E Existing Conditions Reviews

WHITEHORSE CENTRE BUSINESS CASE – STRUCTURAL ENGINEERING REVIEW

DOCUMENT & EXISTING
CONDITIONS REVIEW

WHITEHORSE CENTRE - EXISTING CONDITIONS REVIEW, THEATRE SYSTEMS AND ACOUSTICS**Date: 20th August 2013****Project No: 2013069****Client: Williams Ross Architects****OVERVIEW**

Sewer Asset Information	Address	WHITEHORSE RD NUNAWADING 3131	
	Melway Ref.	48G9	
Dial Before You Dig Sequence No.	Date	26/10/2010	 
	19837461

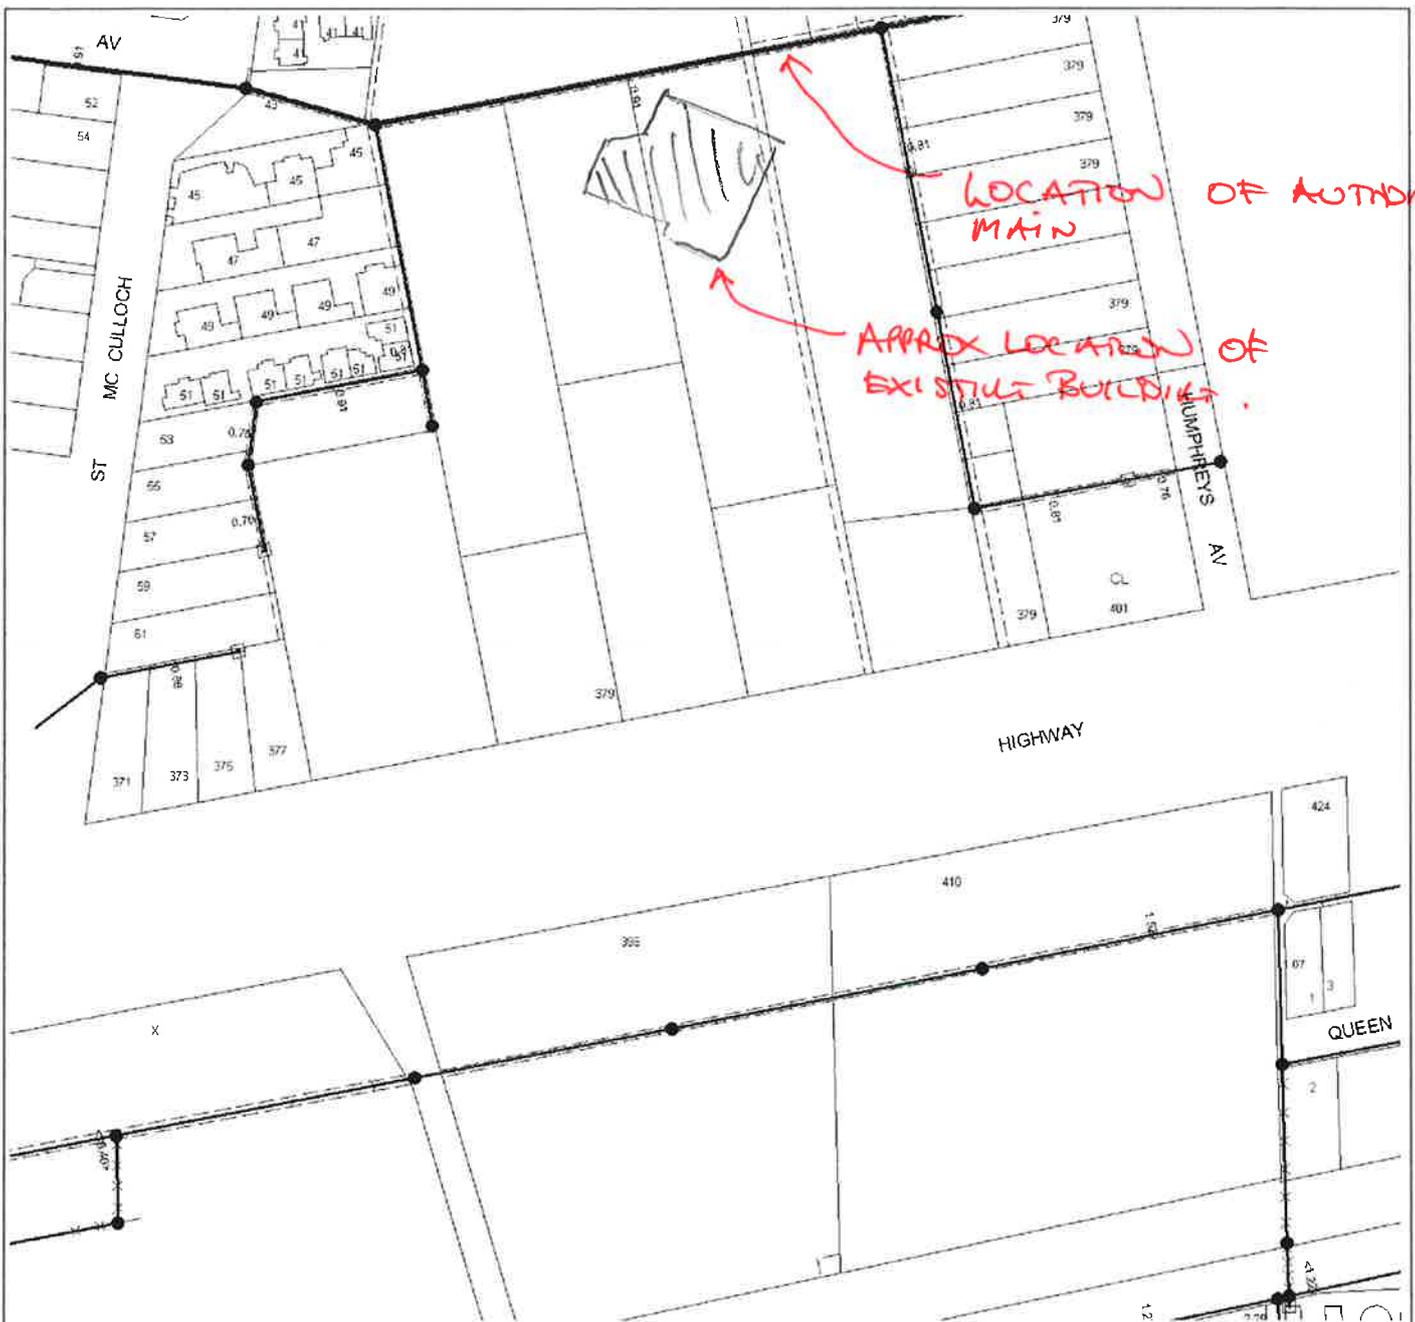
- Optic fibre appears to be not reticulated through the site;
- 30 pair phone cable going to Arts Centre which should be adequate for any future development
- Yarra Valley Water - There is an authority sewer main that runs across the site just north of the existing building. This is an authority main and any development would most likely **not** be allowed to build over the main. Relocation may be an option but could be expensive. Ideally the building would need to remain south of the sewer main. Refer attached sketch. Investigation as to options will be required during further stages.
